INDIANA DEPARTMENT OF TRANSPORTATION

AGENDA

June 20, 2013 Standards Committee Meeting

SPECIFICATION, SPECIAL PROVISIONS AND DRAWINGS
REVISION TO STANDARD DRAWINGS

706-MSRW-05 RAILING TYPE FC AND MOMENT SLAB ATOP MSE WALL - PCCP (WITH MARKUPS)

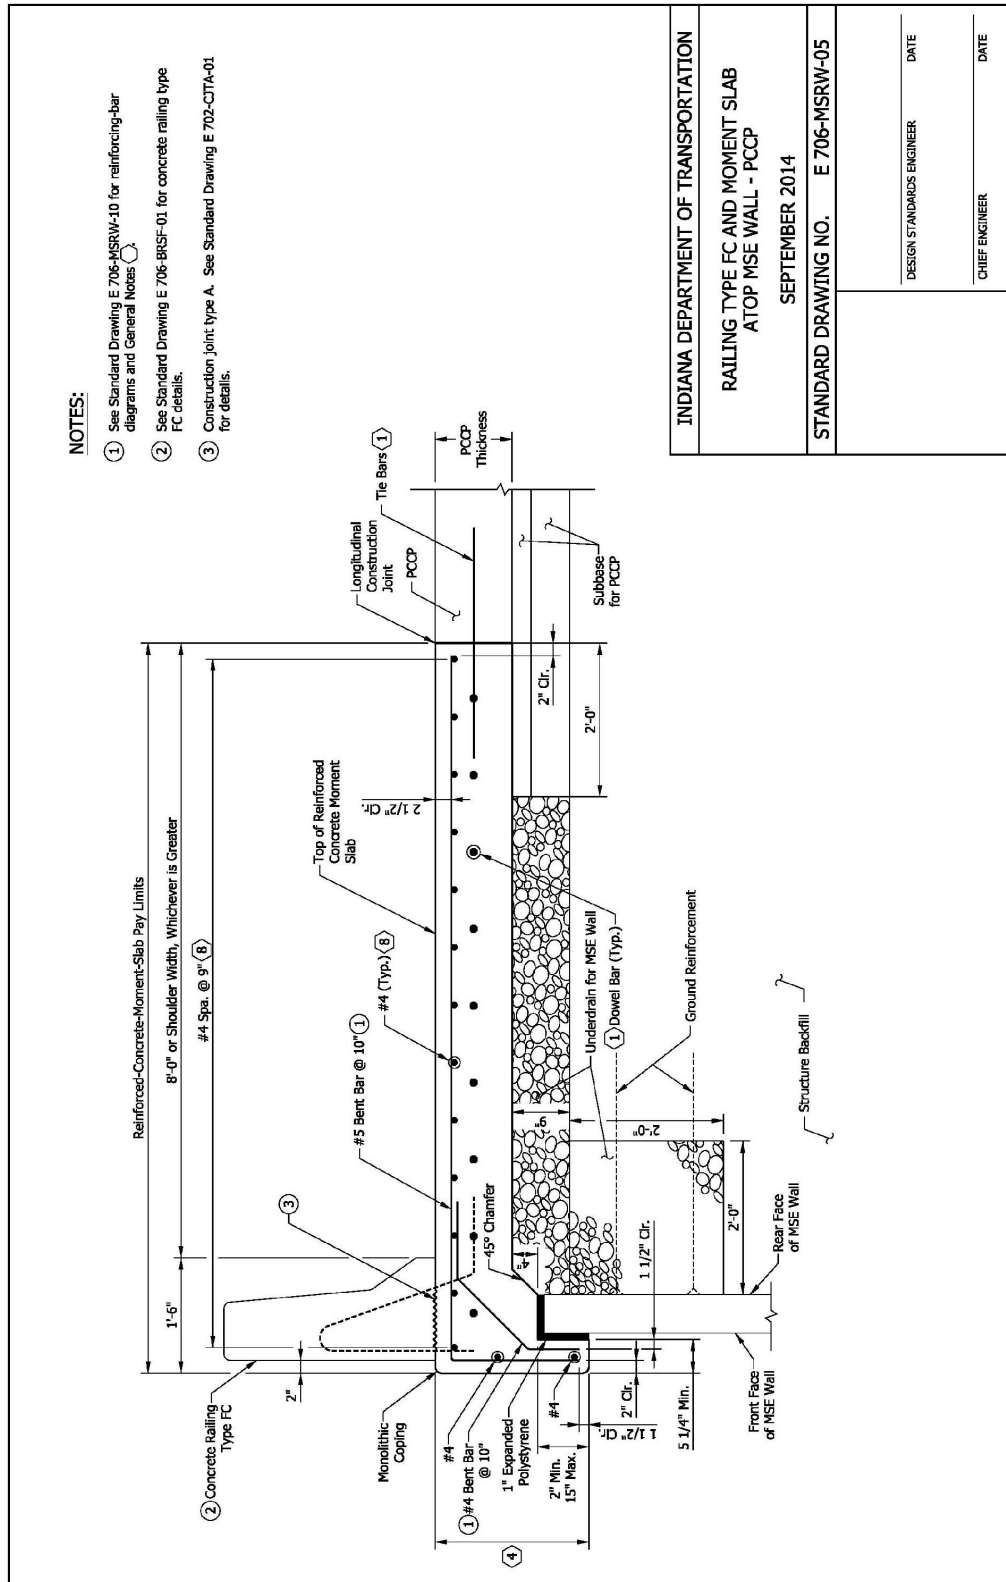
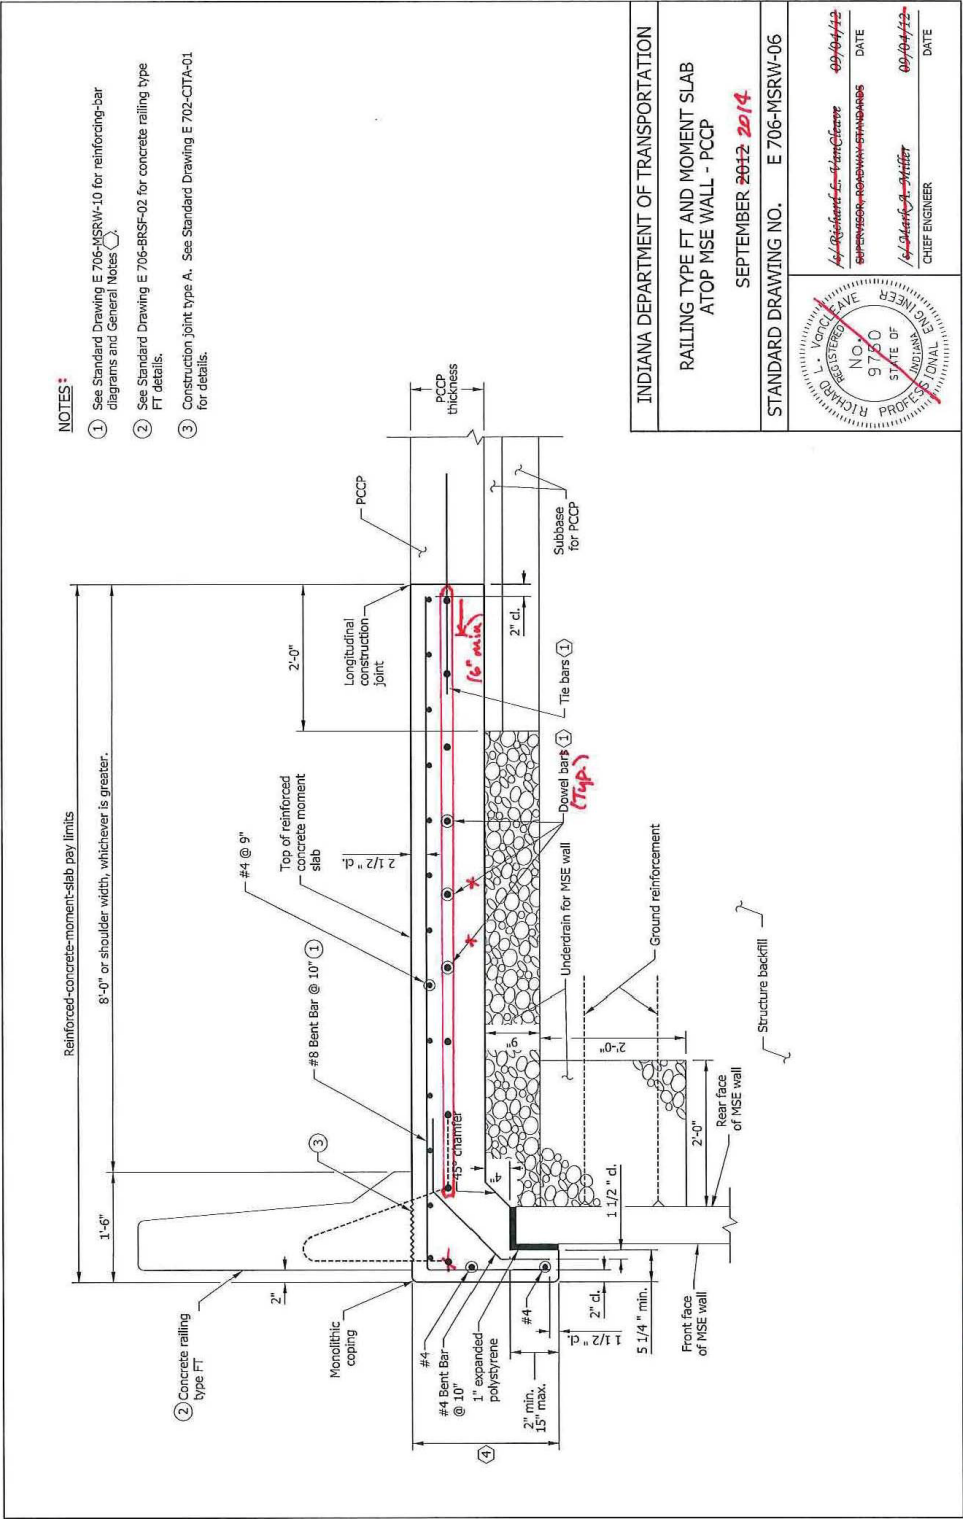
706-MSRW-01 thru -10: Relocated dowel bars in moment slab to reflect 6" minimum clearance from edge of pavement, updated drawing format in general.

update title block.

Update text style, dimension style.

706-MSRW-07 RAILING TYPE FC AND MOMENT SLAB ATOP MSE WALL - HMA
PAVEMENT (WITH MARKUPS)

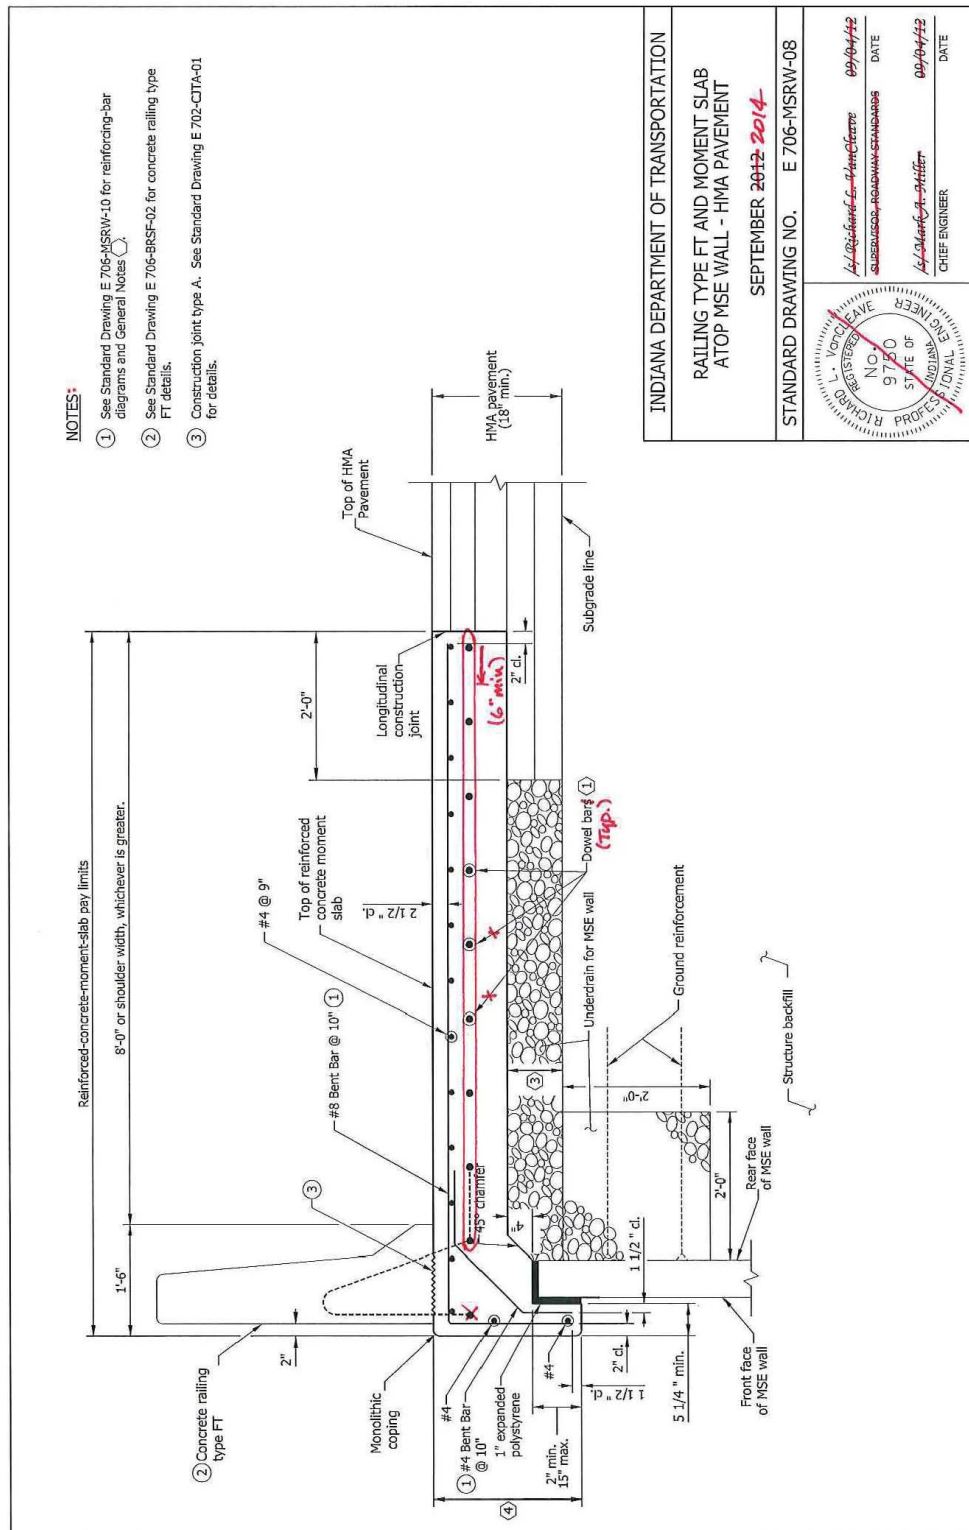
Update title block.

Update text style, dimension style.

706-MSRW-08 RAILING TYPE FT AND MOMENT SLAB ATOP MSE WALL - HMA
PAVEMENT (WITH MARKUPS)

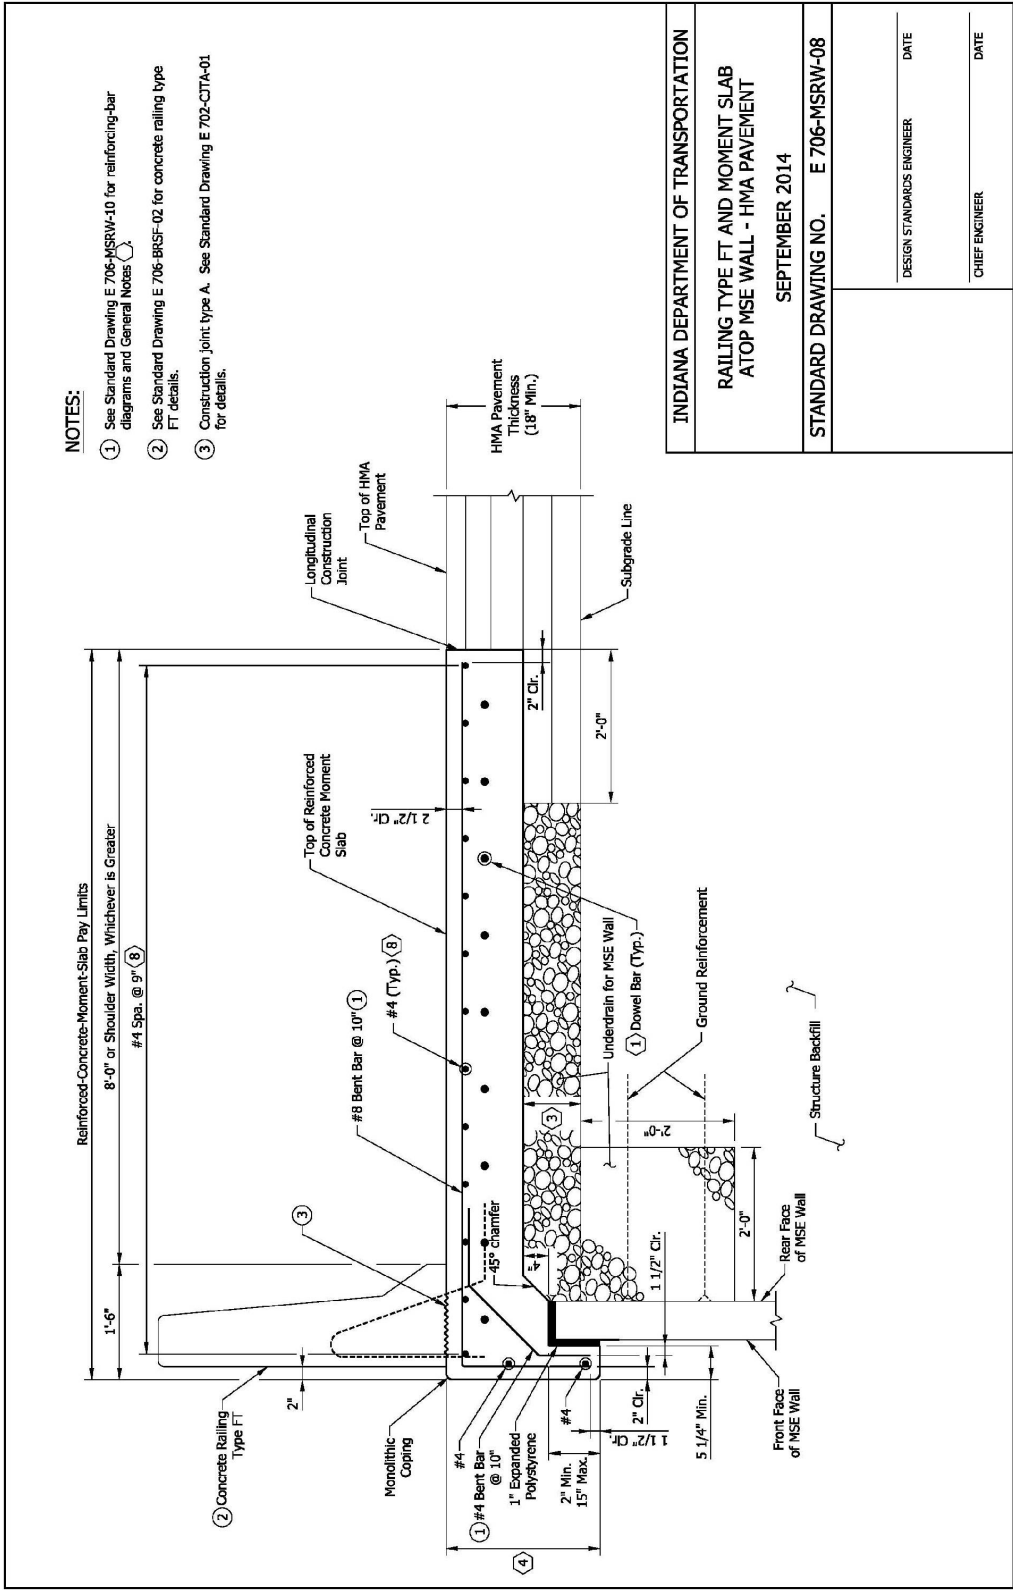
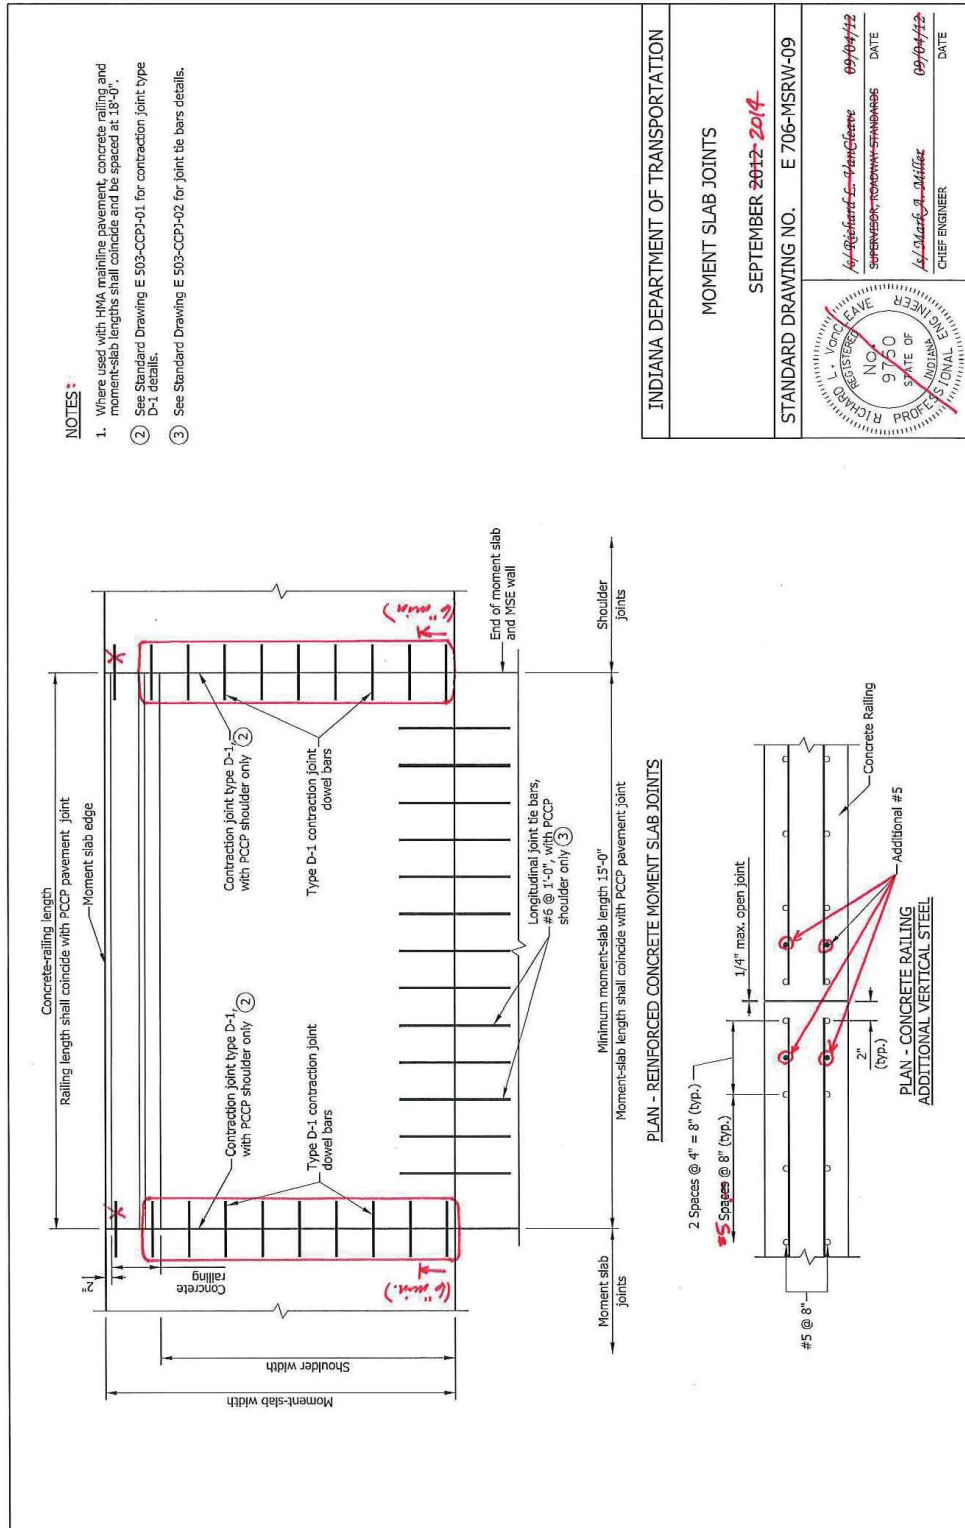
Update text style, dimension style.

706-TTXX-01 CONCRETE BRIDGE RAILING TRANSITION, TTX (WITH MARKUPS)

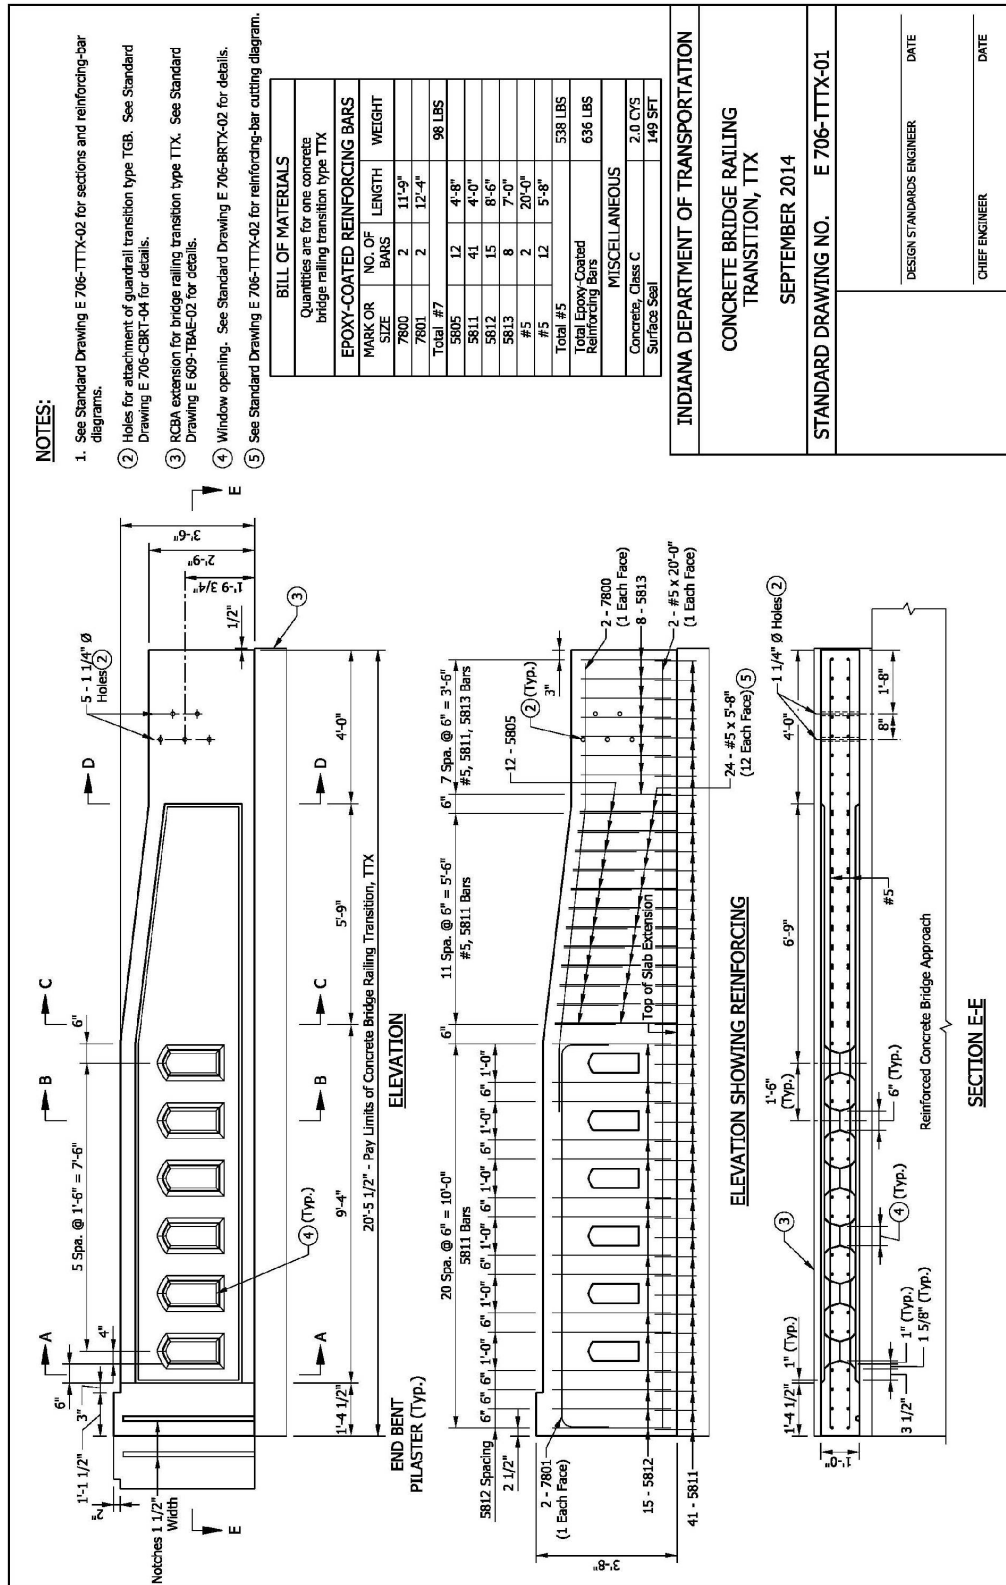
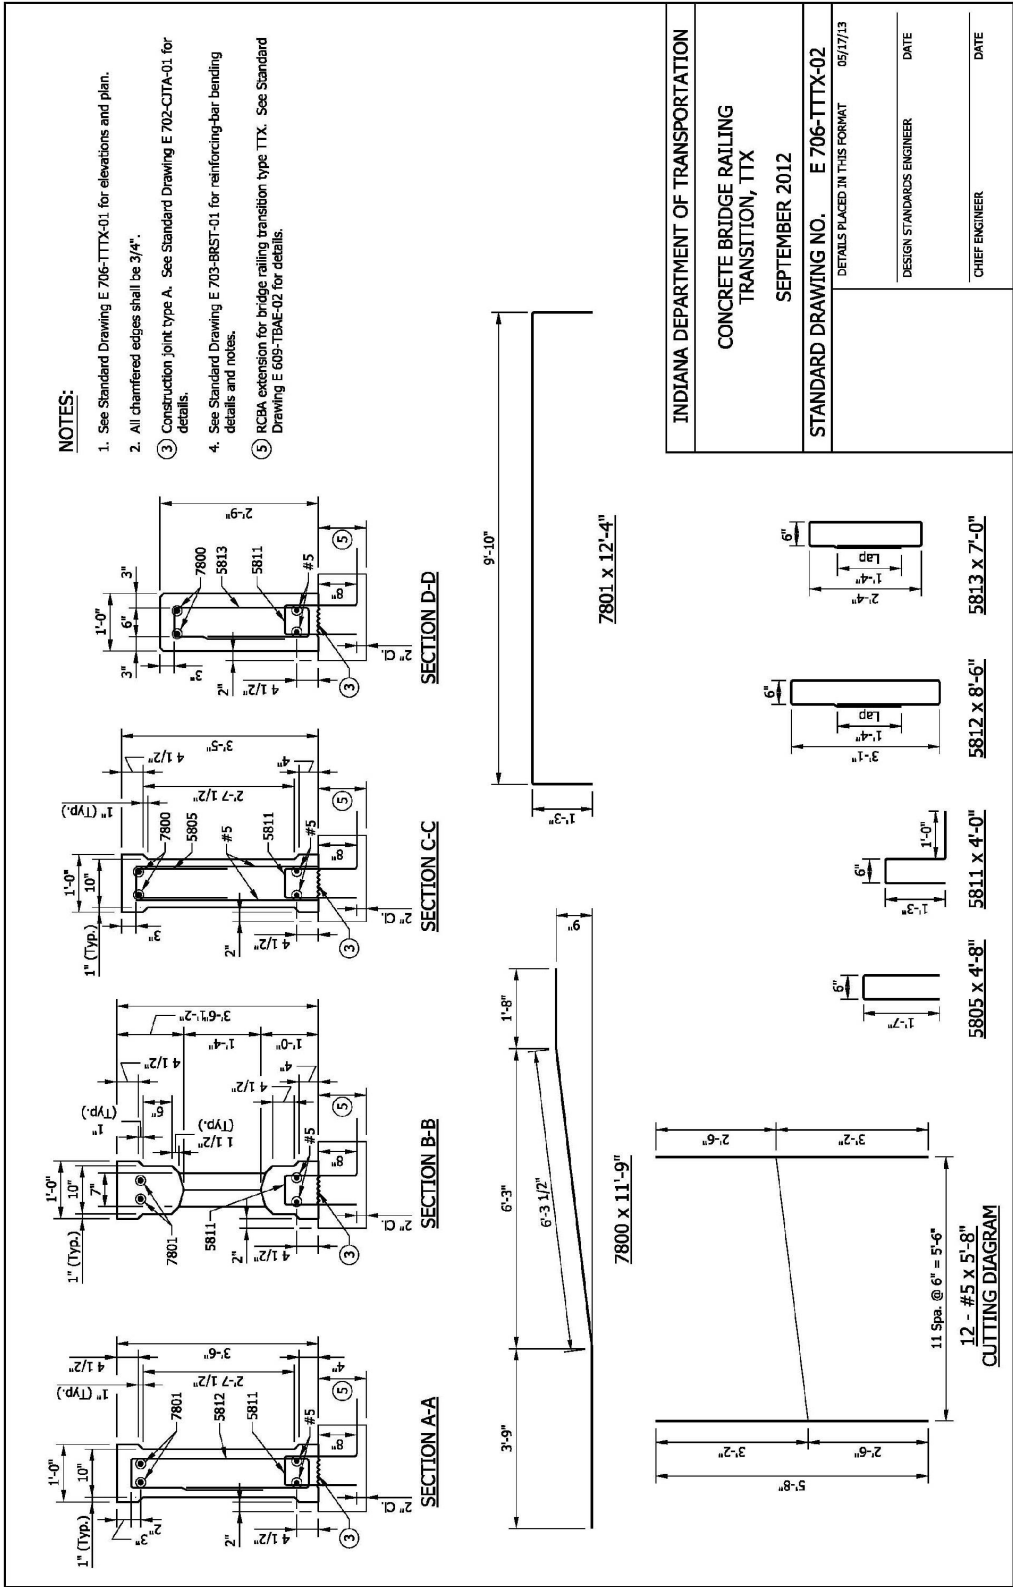
706-TTXX-01 and -02: Corrected spacing description in Elevation, updated terminology to agree with current practice and pay items ("Steel" changed to "Bars"), updated drawing format in general.
